Edinburgh Research Explorer

Force and pressure investigation of modern asymmetric spinnakers

Figure 1: Auto-correlation of the pressure signals for three trims.

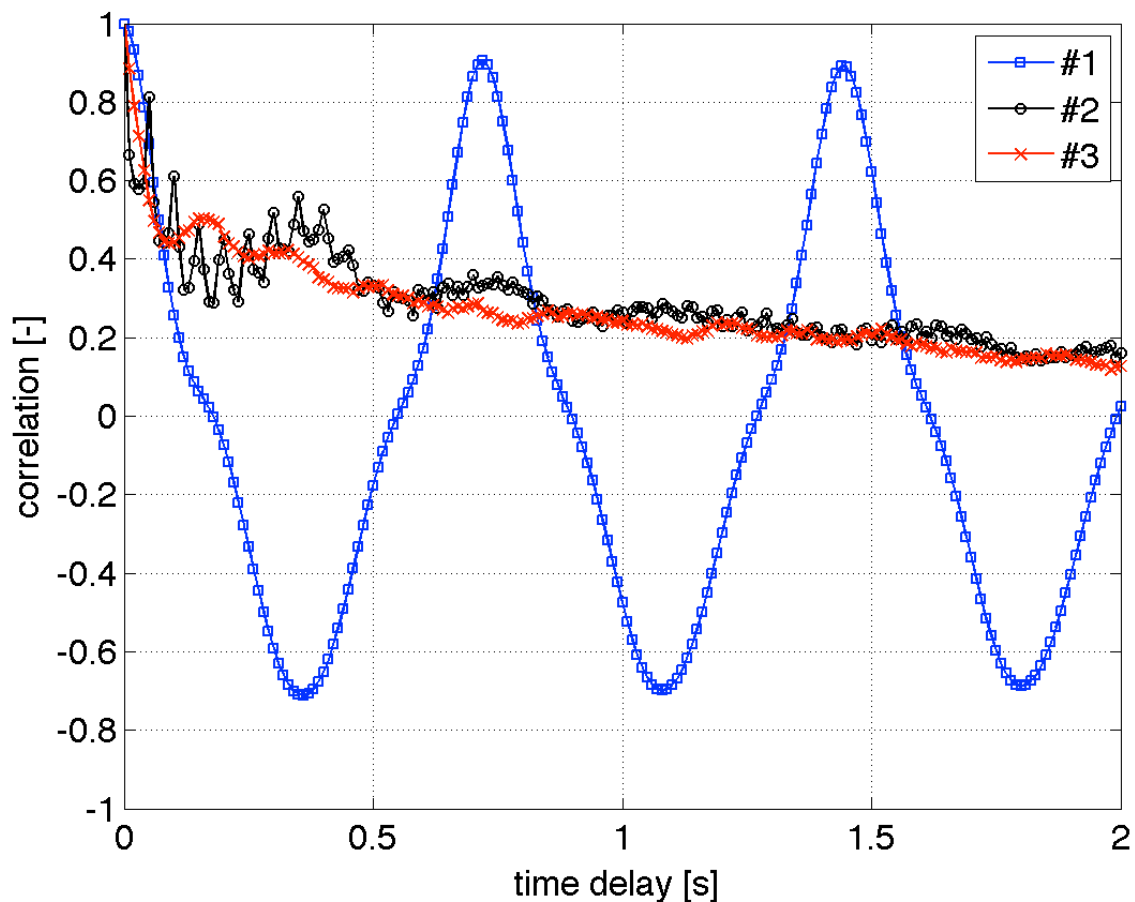
Some clarifications are necessary about the flapping and non-flapping trims. With regard to the comment by William Lasher, the non-flapping luff leads to a significant force reduction in the A3 because it is correlated to a significant increase in separated flow. In fact, figure 11 of the paper shows the separation point of the A3 moving from roughly the 60% of the chord to roughly the 50% of the chord, when the sheet is tightened to stabilize the luff. The anticipated trailing edge separation leads to a significant reduction of the suction after the turbulent reattachment. Conversely, the flapping and non-flapping trims of the A1, named trim #1 and #3 respectively in figure 10 of the paper, show similar pressure suction and trailing edge separation. In particular, with regard to the comment by Grant Spanhake, the luff flaps at 1.4 Hz in trim #1, while does not flap in all the other trims. Figure 1 shows the auto-correlation of the pressure signal measured on the leeward side at the leading edge for the three trims #1, #2 and #3.

The drive force achieved by trim #1 is lower than the drive force achieved by trim #2. However, in the unstable full-scale condition, trim #2 and trim #3 might be unrealistic, because to stabilize the luff, the sheet has to be tightened significantly (as in trim #4). Hence, in full-scale condition the flapping trim would result in a larger drive force than the non-flapping trim.

Figure 1: Photograph of the pressure tap.

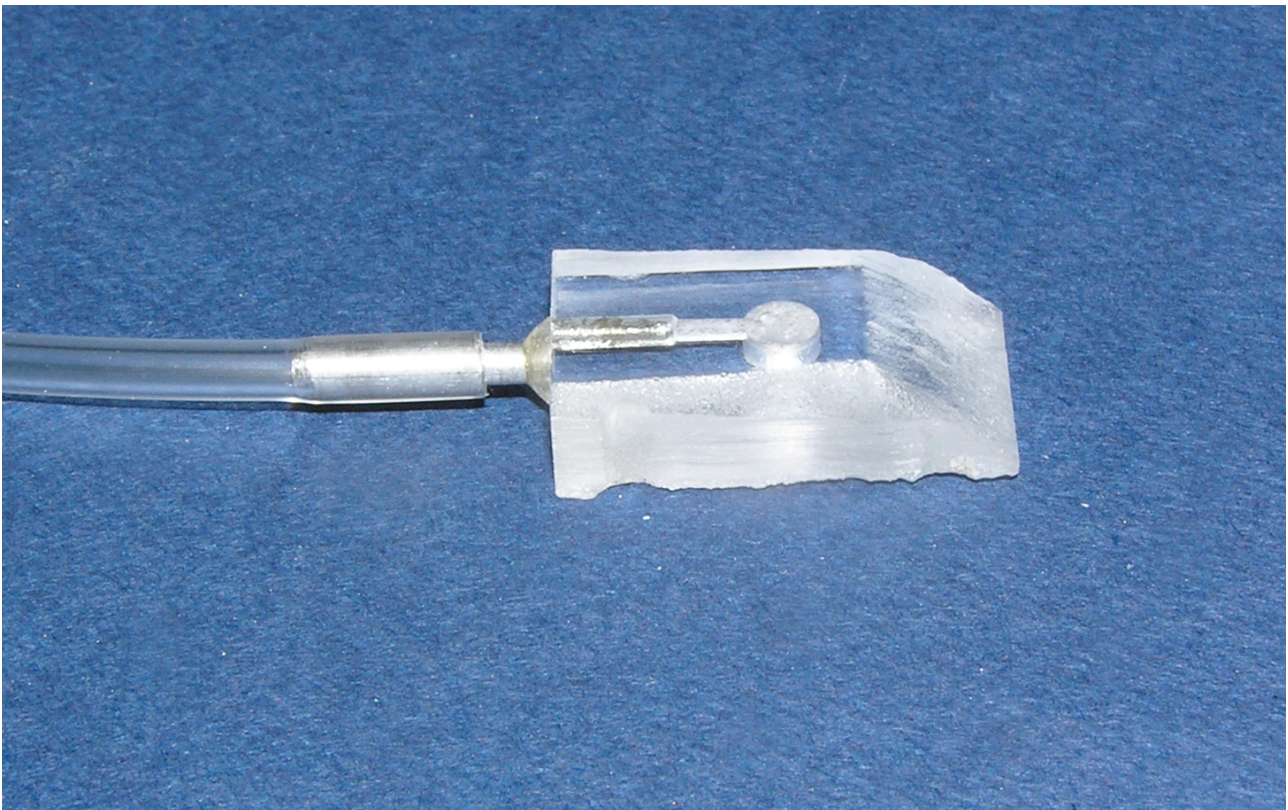
Page 3, Table 1: I would suggest adding a Mid girth # or mid girth % to the table (See page 5 comments).
3.3: It would be good to see a close up photo of the pressure taps.
3.3: At a later date it would be good to see the results of (Twisted vanes verses non-twisted).

With regard to the comments by Grant Spanhake, figure 2 shows one of the pressure tap adopted. The tap is a truncated cone with a rectangular base, the base of which is 17x10 mm^2. The transparency of the material allows the hole on the base to be seen, and is connected with a stainless steel tube to a plastic pressure tube.
